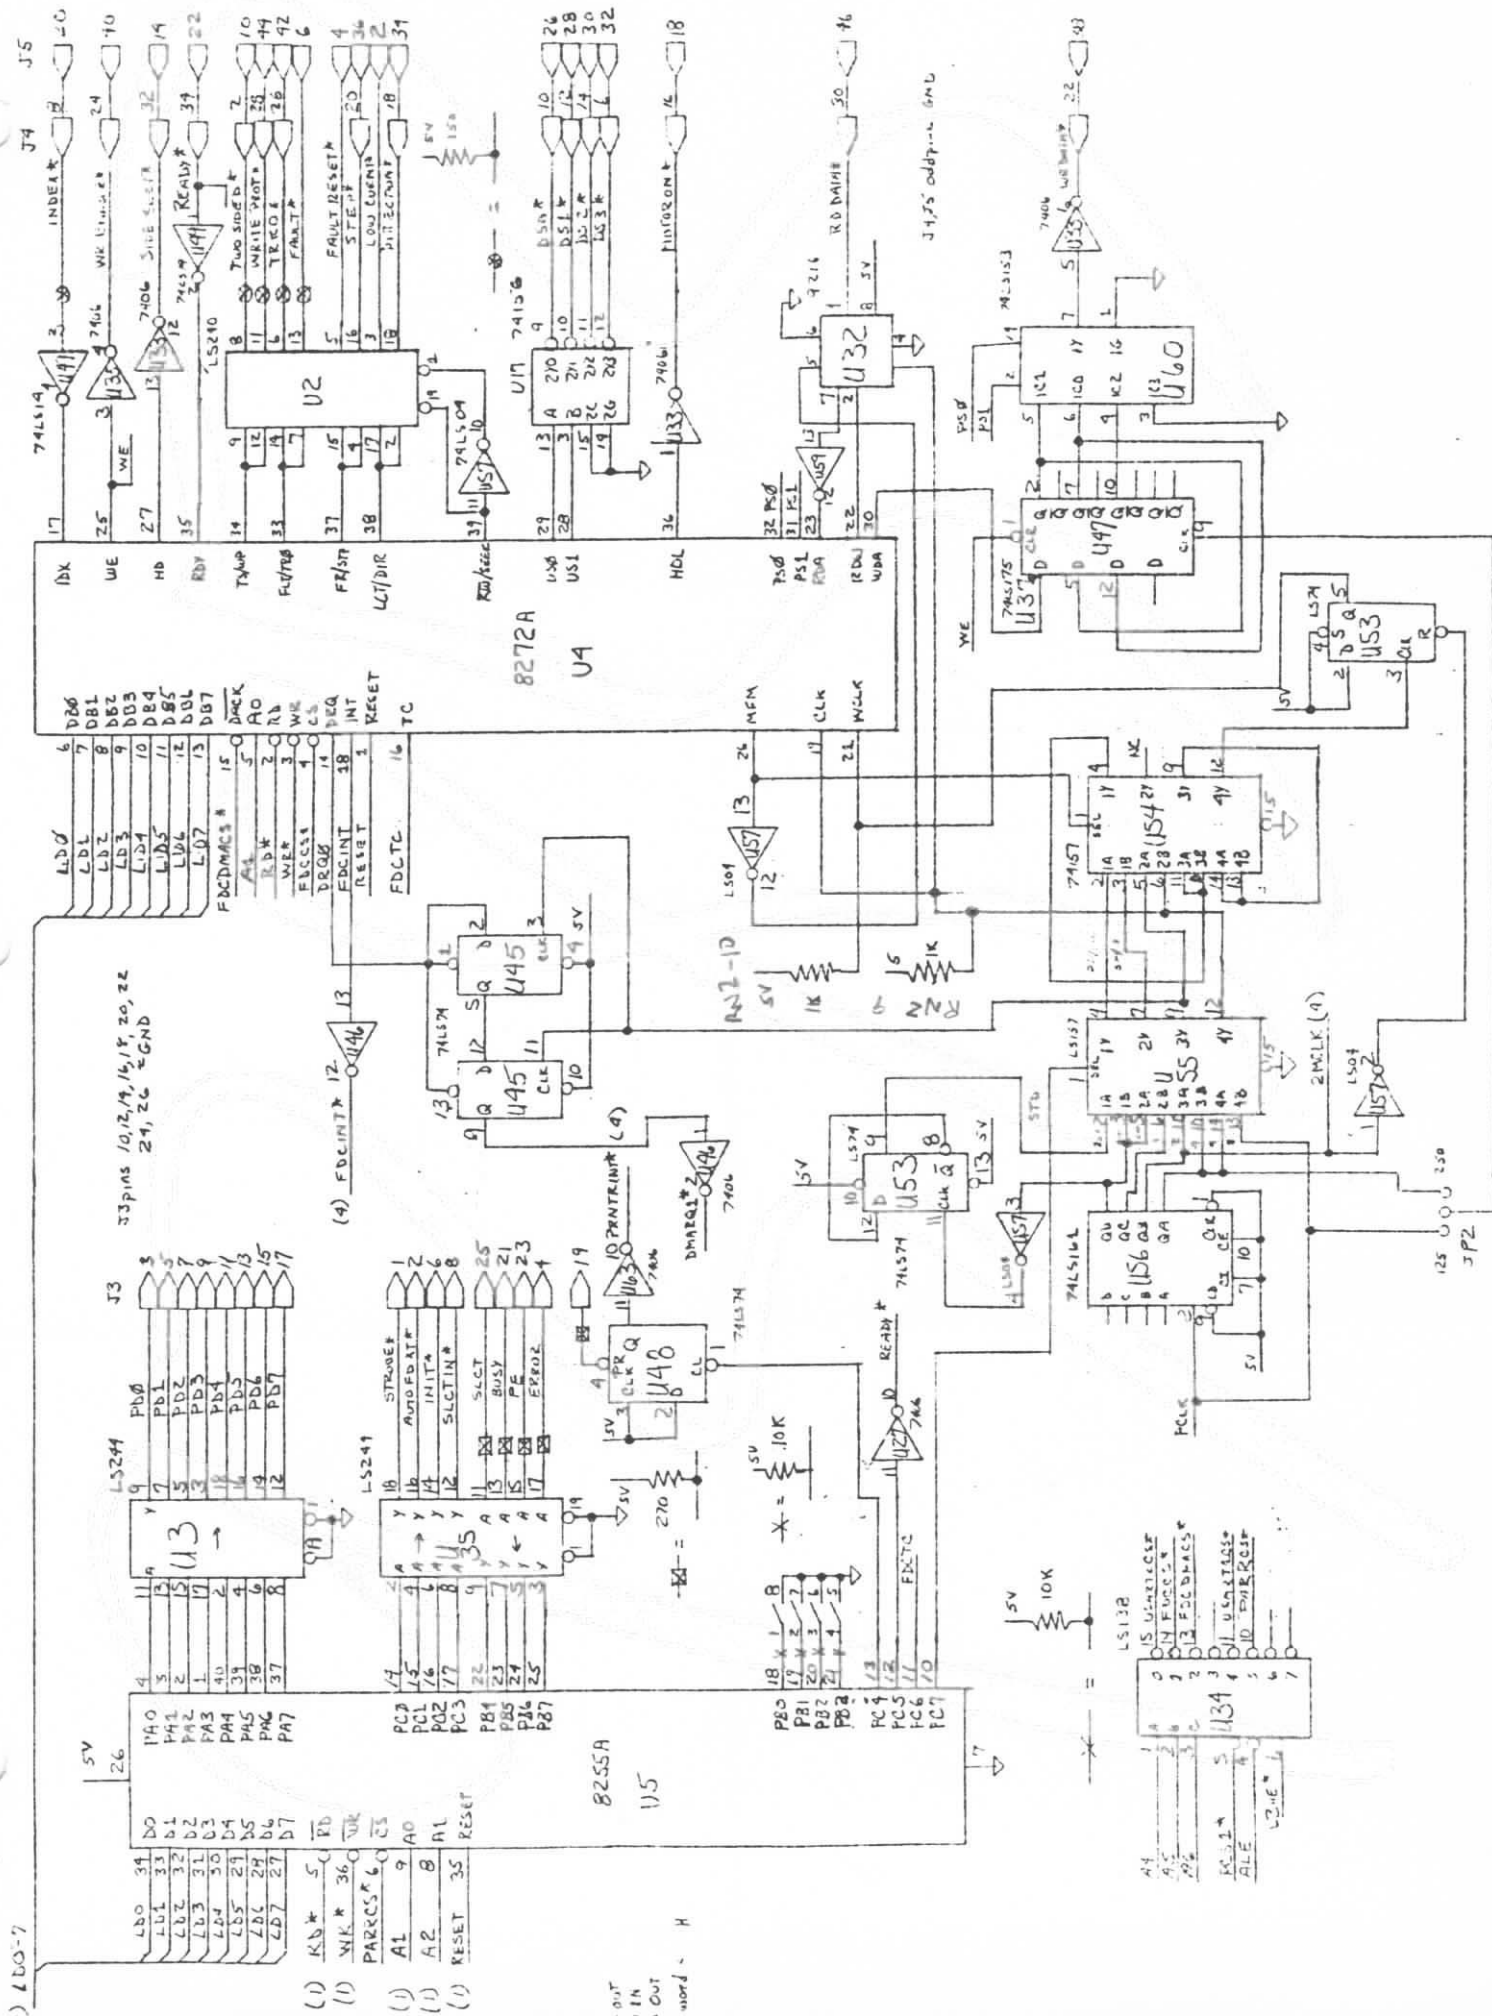
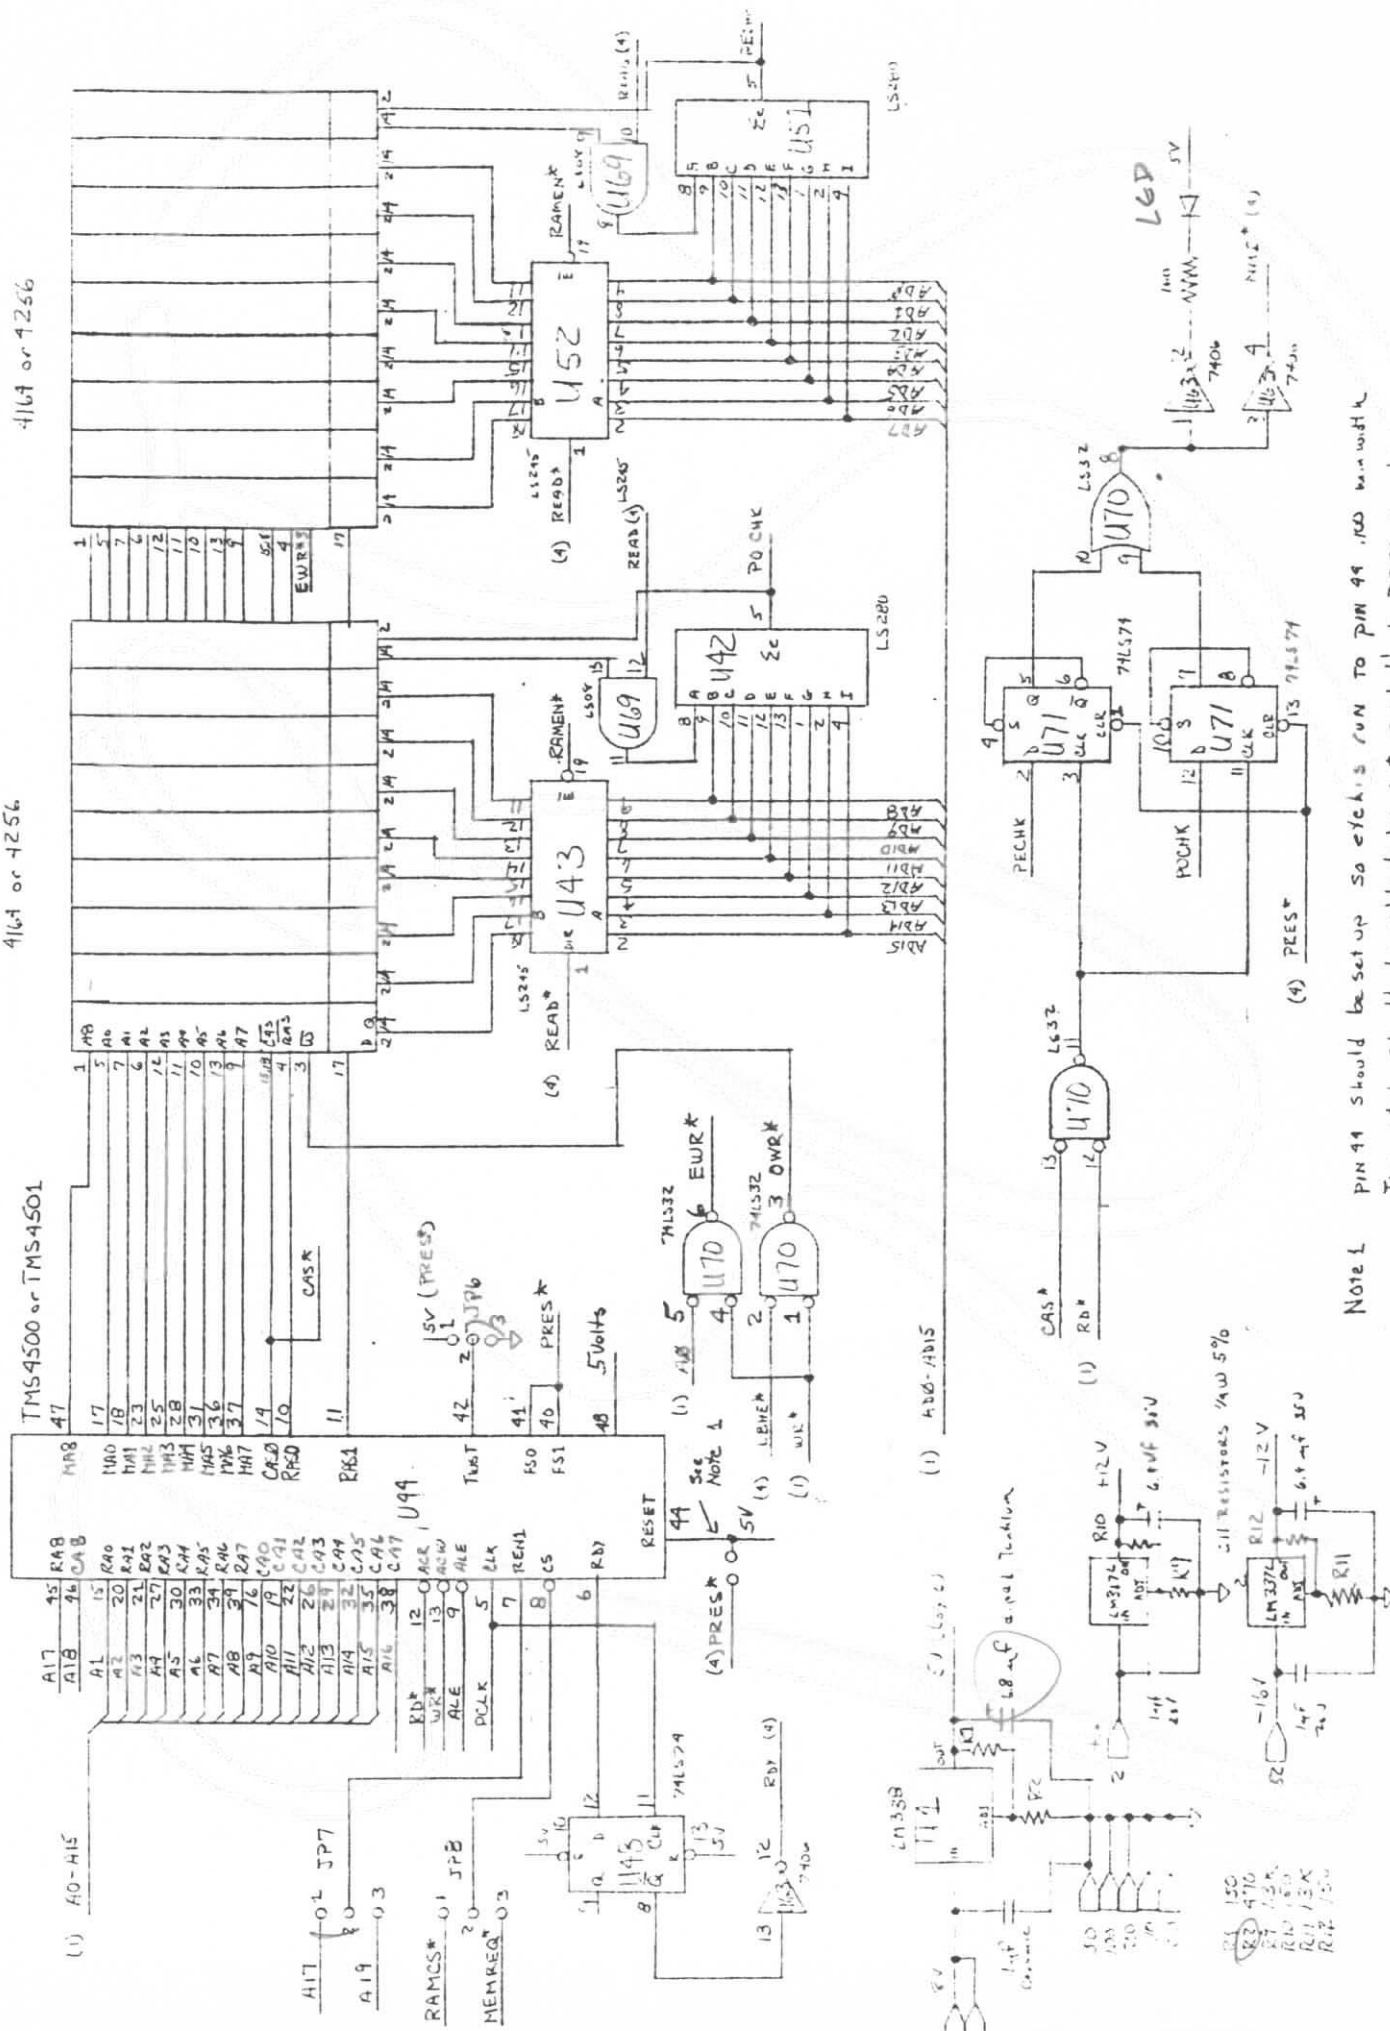
4164 or 4256

4169 or 4256

Note: PIN 44 should be set up so each is run to PIN 44, no burn with

The etch should be able to be cut such that PRES can be connected to pin 19 when a jumper is installed. and the 5V etch is cut.
